Final Report - Corrections Required **Application No. LUPL-25-0008**

Document Filename : 241010_BLR Village C Land Use Plan.pdf

BANNING LEWIS RANCH - VILLAGE C
LAND USE PLAN
COLORADO SPRINGS, CO
LAND USE PLAN

*Dwelling, Single-family Detached; Dwelling, Single-family Attached; Dwelling, Two-family (duplex).

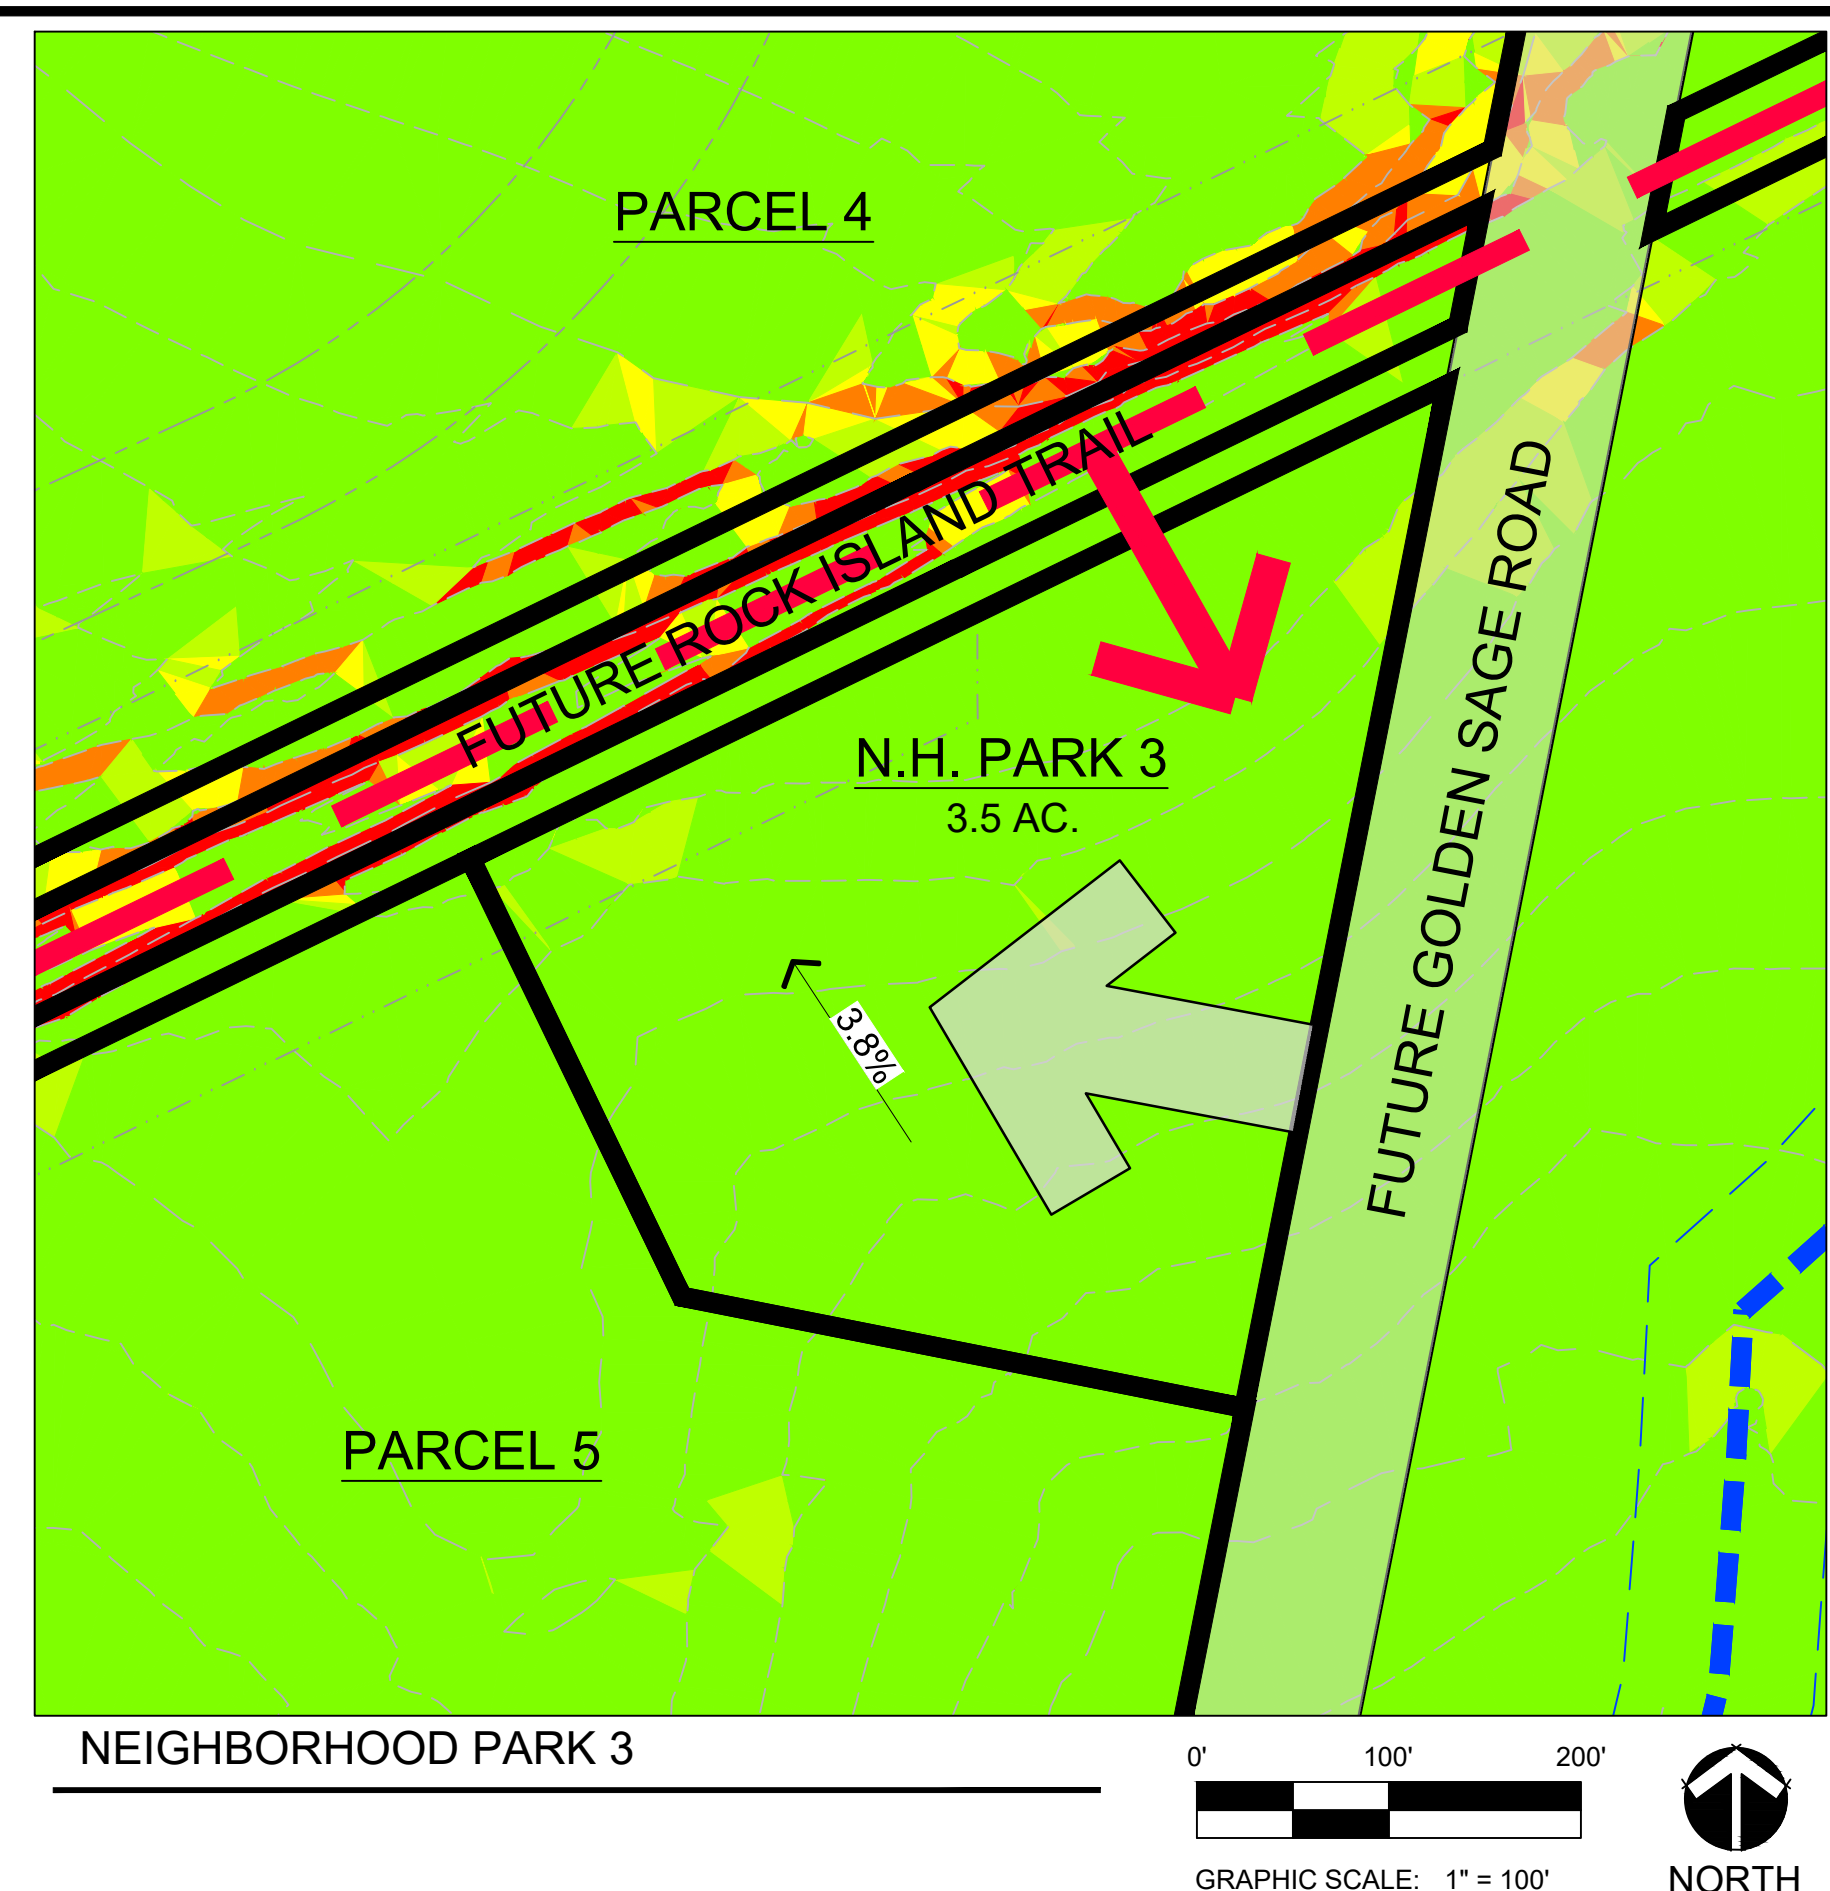
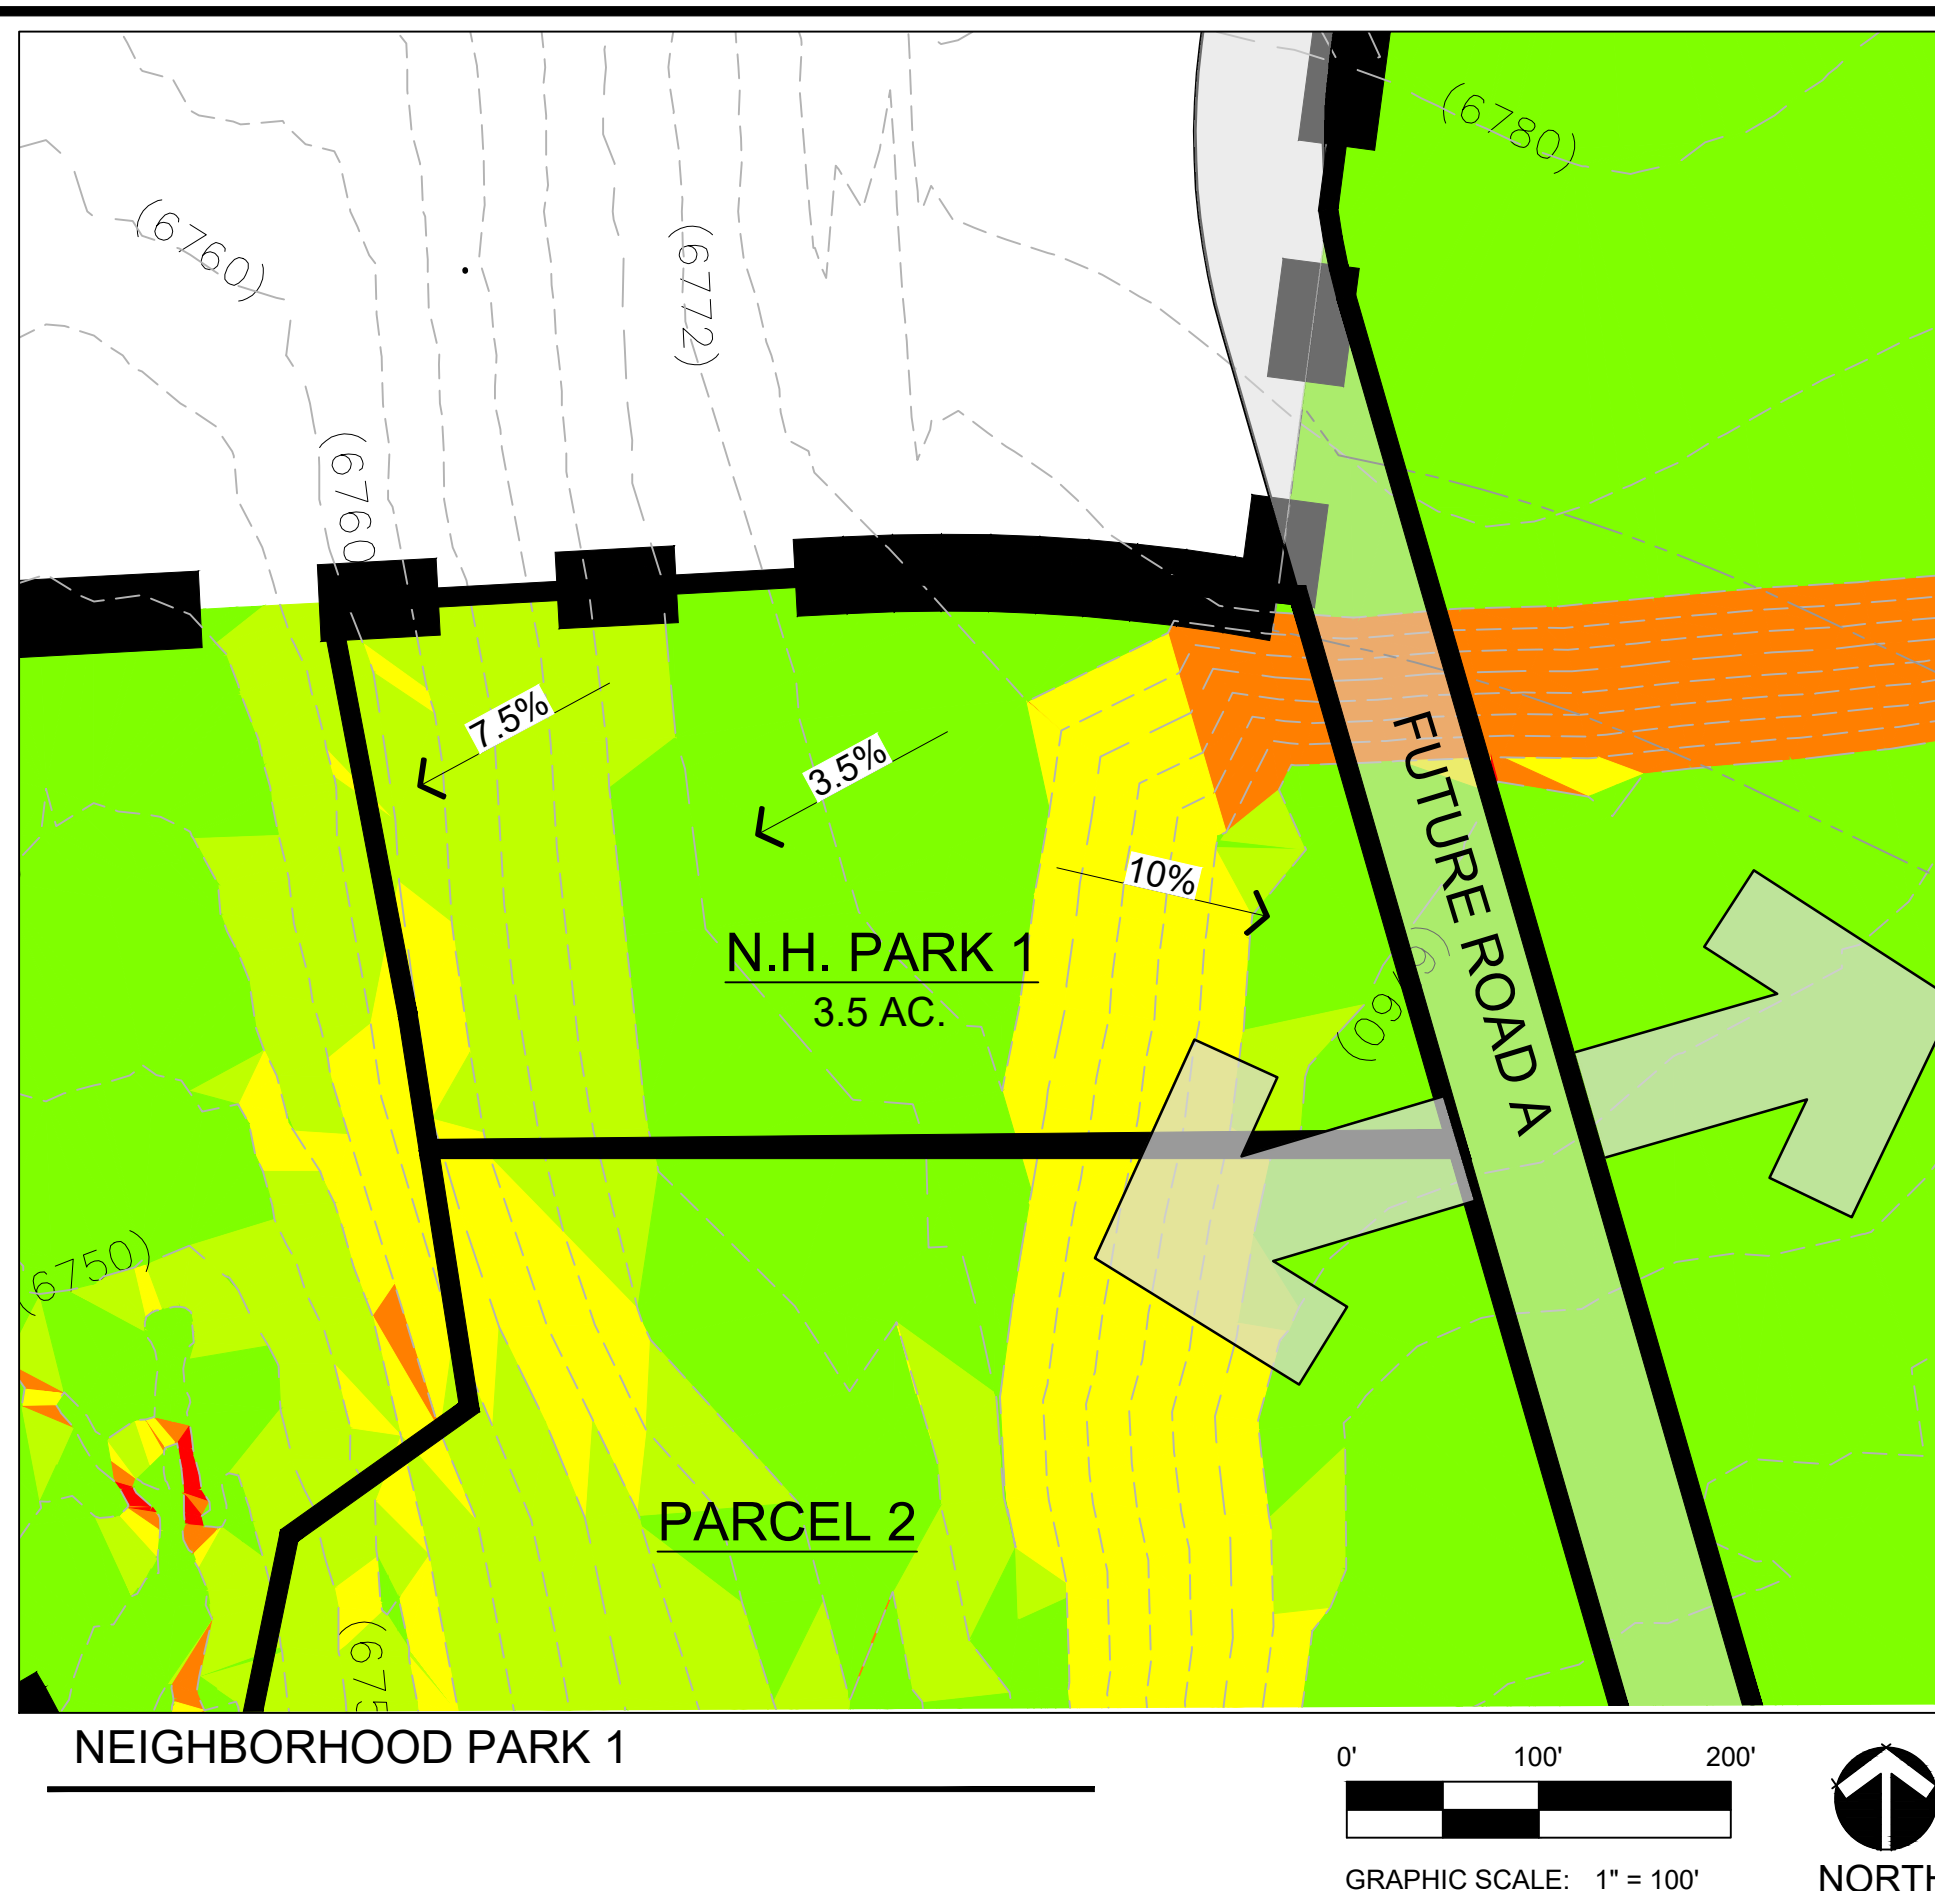
53	2	Tamara Baxter : Planning	Please use this on the coversheet as well.
54	2	Tamara Baxter : Planning	What does this residential encompass?
30	3	Caroline Miller : Planning	This graphic doesn't match the LUP Bubbles shown on page 2, park is not next to Public Safety.

Please use this on the coversheet as well.
